Subject: MHI's Responses to US-APWR DCD RAI No.823-5933 Revision 3 (SRP 19)

Responses to Request for Additional Information No.823-5933
Revision 3

RAI NO.: NO. 823-5933 REVISION 3
SRP SECTION: 19 – Probabilistic Risk Assessment and Severe Accident Evaluation
APPLICATION SECTION: 19
DATE OF RAI ISSUE: 09/06/2011

QUESTION NO.: 19-549

Figure 19.549-1 Loss of Offsite Power Event Tree

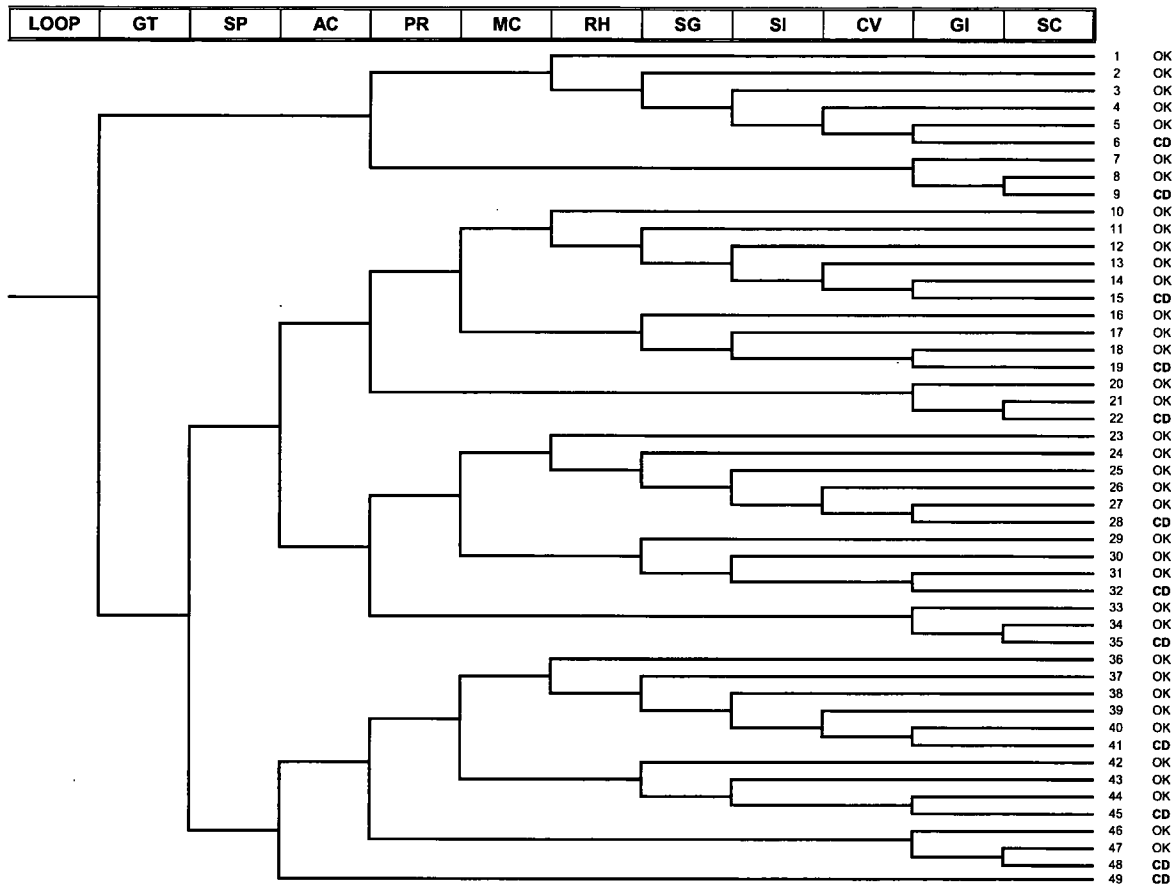
Based on the US-APWR DCD Chapter 8, it states, "In the US-APWR design, power to the shutdown buses can be restored from the AAC sources within 60 minutes." Given a SBO event in POS 4-3 and POS 8-1, the time to RCS boiling is 20 minutes and 40 minutes respectively, as documented in the revised response to RAI 19-493. Therefore, following restoration of the AAC source or offsite power, the RCS could be boiling. The event tree for loss of offsite power with 1E CTG failure credits RHR recovery without the need for standby RCS injection. The staff believes that RCS injection from either charging or SI will be needed to restore RCS level and to permit recovery of the RHR function. Please modify the event trees to require SI or charging before RHR recovery. This change will require the loss of offsite power events to be resolved and requantified. Please update the DCD and the PRA as appropriate with the revised loss of offsite power results.

In response to this RAI, MHI has revised the event tree (DCD Figure 19.1-20) for loss of offsite power; see the revised Figure 19.549-1 below. In the revised event tree, an event heading "MC" (RCS makeup provided by a charging pump) has been added between event headings "PR" (CCWS restart) and "RH" (heat removal by standby containment

spray/residual heat removal [CS/RHR] pumps). The total core damage frequency (CDF) during LPSD operation was re-quantified using the revised event tree, Figure 19.549-1, and the following analysis conditions:

1. In mid-loop operation states preceding and following refueling, POSs 4 and 8 respectively, RCS boiling is conservatively assumed to occur with a (bounding case) probability of 1.0 during a SBO event; disregarding the likely success for AAC power or offsite power recovery prior to the RCS boiling.

2. Failure of replenishing RCS makeup via charging pump (event heading "MC") followed by a loss of heat removal via standby CS/RHR pumps (event heading "RH") in POSs 4 and 8 due to the absence of any RCS inventory.

3. For POSs 3, 9, and 11, in which Class 1E ac buses are supplied AAC power or offsite power prior to RCS boiling, the frequency for core damage scenarios #19, and #32 are considered to be zero because RCS makeup for RHR restart is not necessary for these scenarios. Failure of action to replenish the RCS inventory during these POSs will have no impact on the heat removal capability via CS/RHR pumps.

4. Failure to replenish RCS makeup by charging pump (event heading "MC") would result in failure for RCS injection by charging pump (event heading "CV") because of use of a common system.

Subsections 19.1.6.1 and 19.1.6.2 will be revised to reflect the revised PRA model and results after closure of other RAIs regarding PRA model changes. The table summarizing CDFs for each POS (Table 19.1-89) and the event tree for loss of offsite power (Figure 19.1-20) will be replaced with Table 19.549-1 and Figure 19.549-1 in DCD chapter 19, respectively.

The loss of offsite power event tree for the LPSD PRA model will be updated to Figure 19.549-1 reflecting the response to this RAI. The model change does not have a significant effect on the LPSD PRA results or PRA insights such as the dominant core damage scenarios, importance measures, or uncertainty analysis results.
